# Addendum to Flood Risk Assessment

**Our ref : 8075-001**  
**Your ref : PA/2014/1360**

**Addendum to Flood Risk Assessment 8075/DH/001/0 dated November 2014 and Response to Environment Agency and Natural England Holding Objection**

Route of Existing Watercourse  
 Barton upon Humber

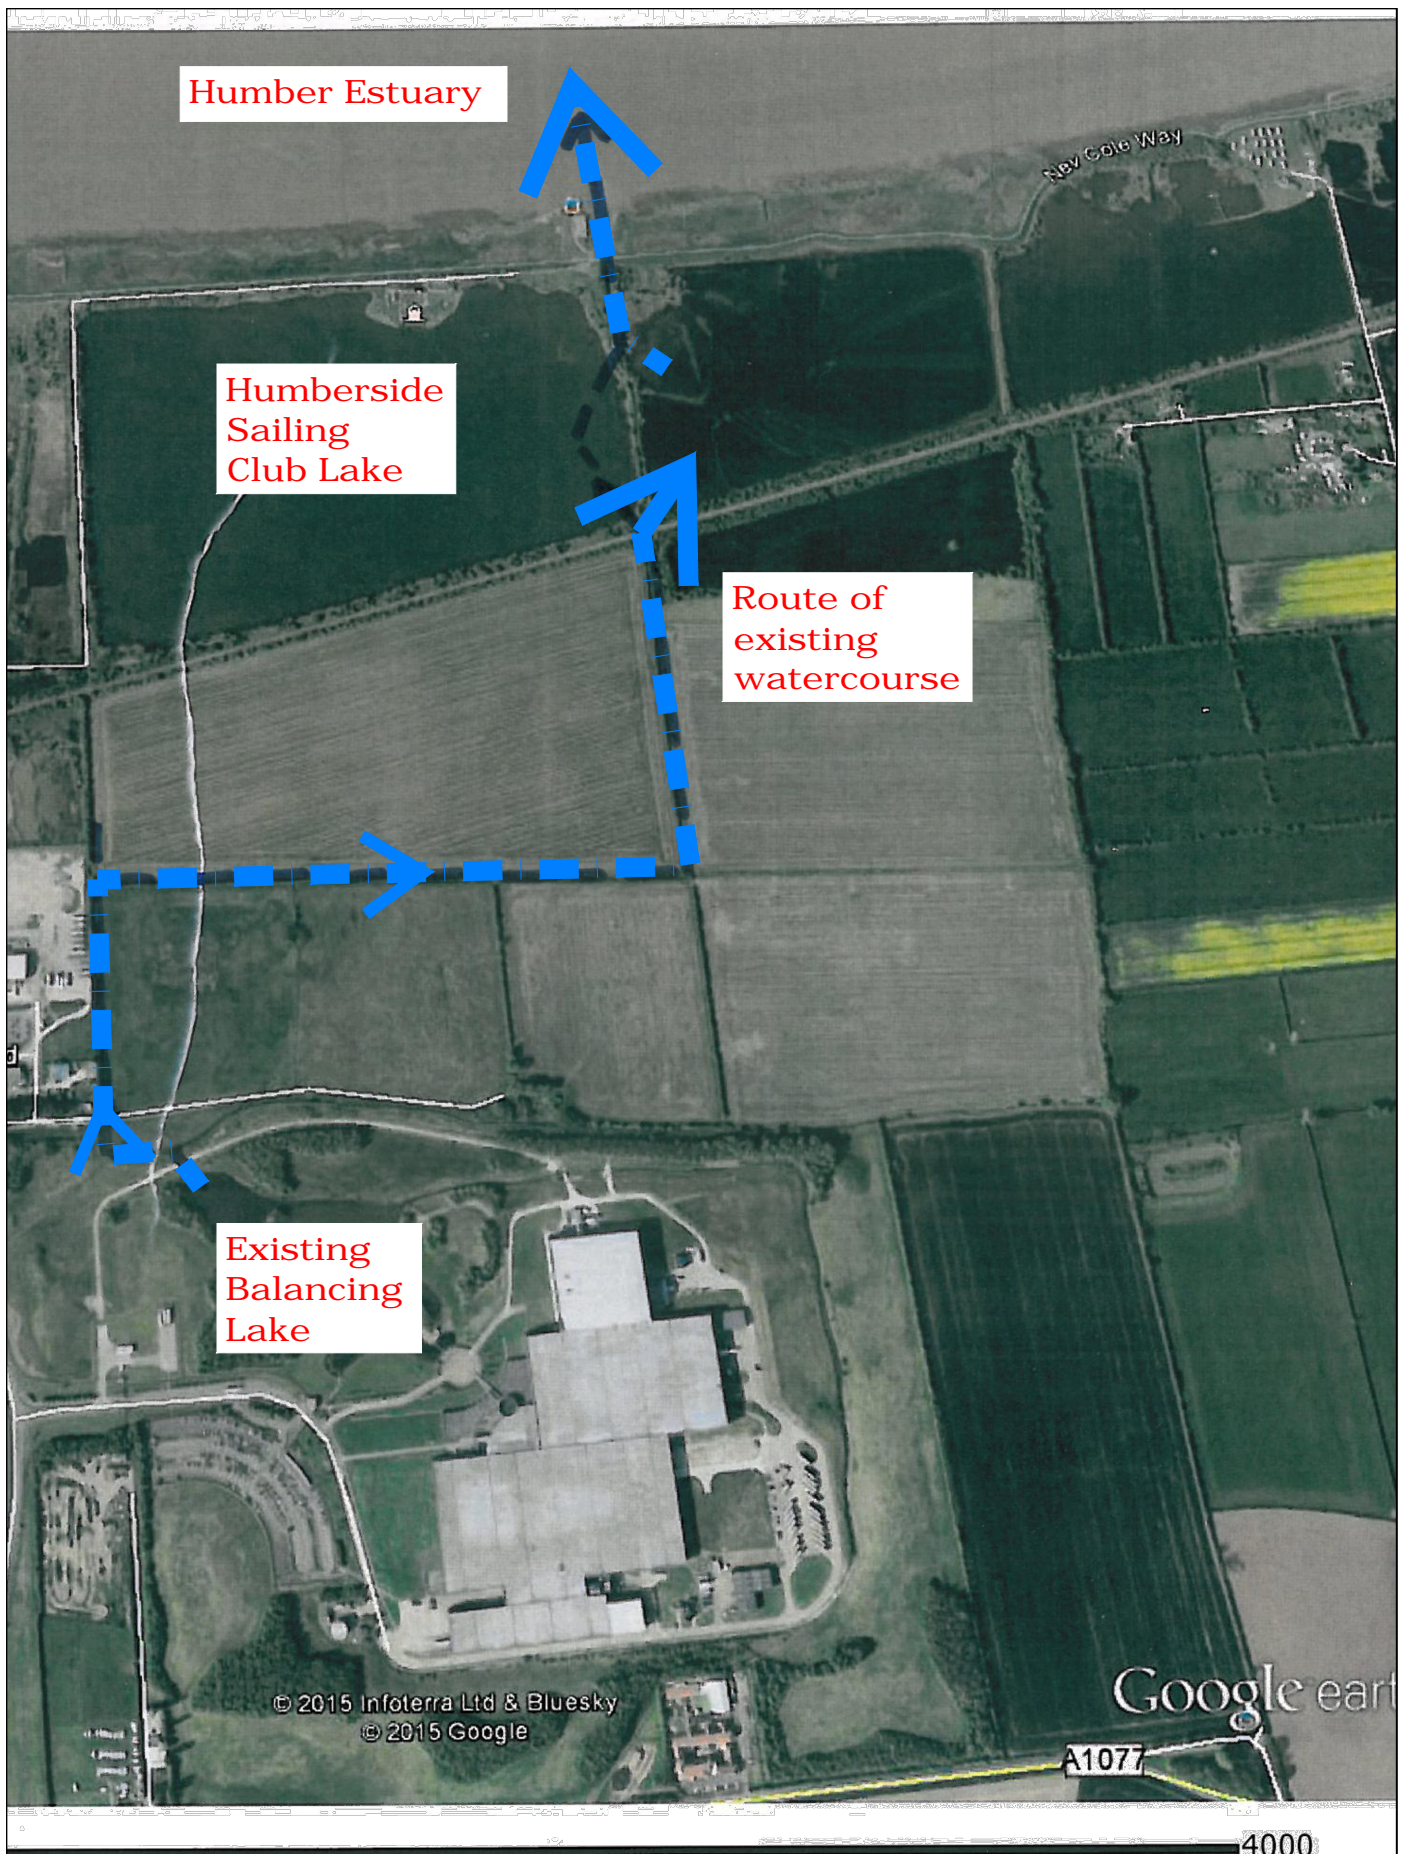
Just for information, the aerial photograph that you sent which showed the route of the IDB drain into the Humber via the sailing club pit did not appear to match up with information supplied to us by Humberside Sailing Club. As you will need to provide information on drainage for the HRA it will be useful to speak to the owners of the relevant pits about drainage in this area.

*Drainage plans which can be used to determine whether the development of the site will result in increased runoff into the Barrow Claypits SSSI which are designated as part of the Humber Estuary SSSI and SPA. These pits already have water quality problem, so any additional drainage from urban areas should be avoided.*

*Clarification whether there is any linkage between the proposed development site and the Humber Estuary SAC, for example from site drainage.*

I confirm that the route of the watercourse as shown on your plan is correct.

The balancing lake currently discharges into an Internal Drainage Board ditch to the north of the site which then runs towards the existing Lakes toward the Estuary. The ditch currently discharges into the lake (Barton Wild Foul Lake) then into the Humber Estuary. This has been confirmed by North Lincolnshire Internal Drainage Board (correspondence attached) and is shown indicatively on attached plan referenced 8075-003.
